SK21685-24

Cinders Farm, Nr Ruabon

Revised Cinders Lane Proposed Passing Bays (2 x HGV and 1 x Private Car Bay)

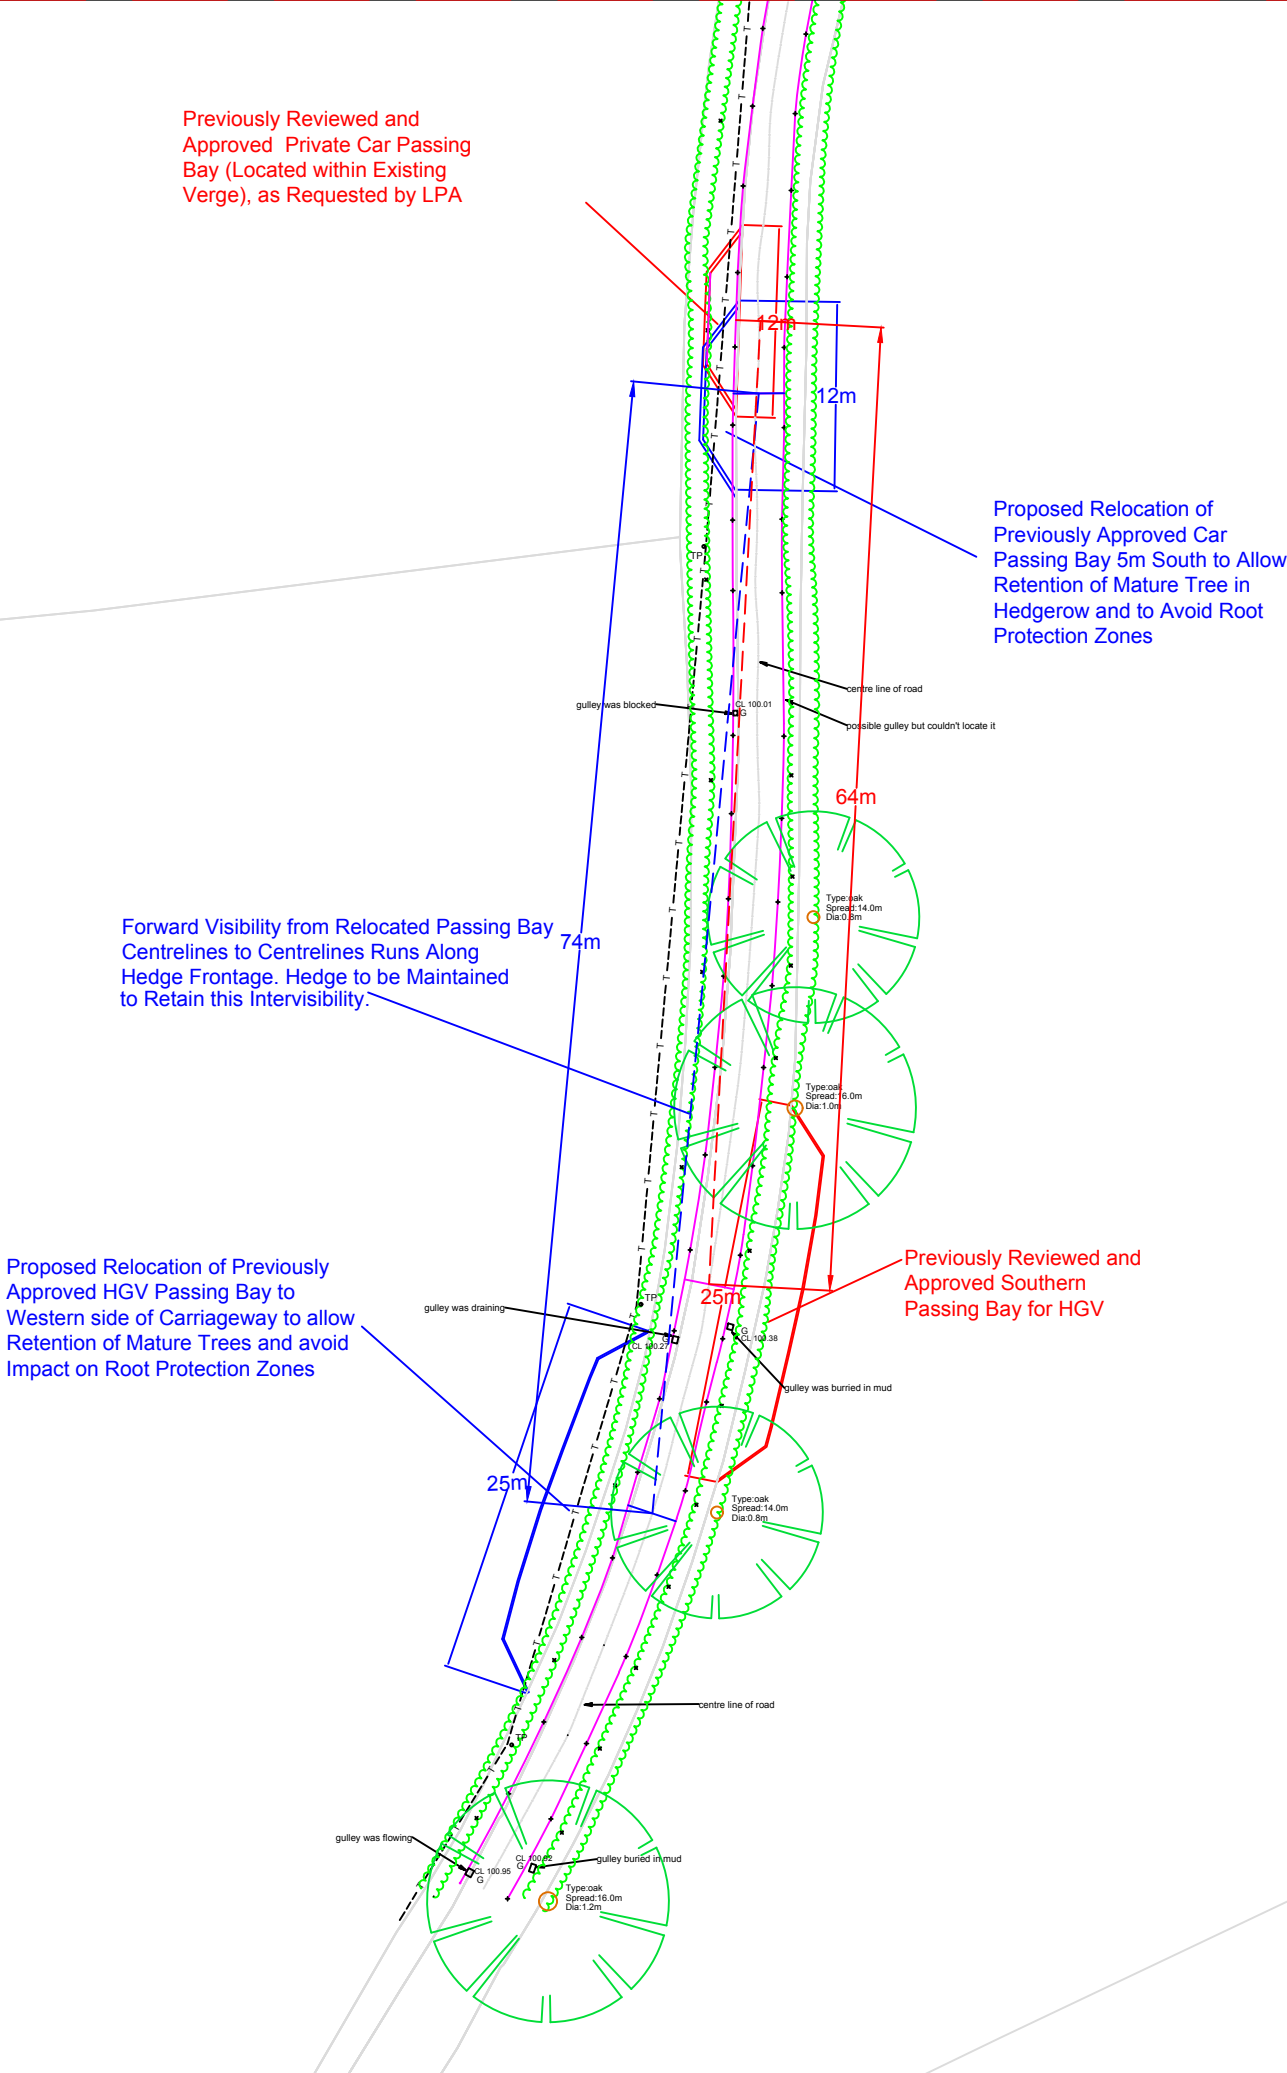
Previously reviewed and agreed HGV and car passing bays shown in red, with modified passing bay positions shown in blue.

Relocated passing bays are proposed to ensure the bay provision does not adversely impact on nearby mature trees and any root protection zones.

The proposed relocation of the central car passing bay simply moves the passing bay southwards by 5m.

The southern HGV passing bay is switched from the eastern side of the carriageway to the west and moved southwards, to avoid impacting on the existing mature trees and telegraph pole on the western side of the carriageway.

All relocated bays will be provided either within land the applicant controls or the adopted highway.
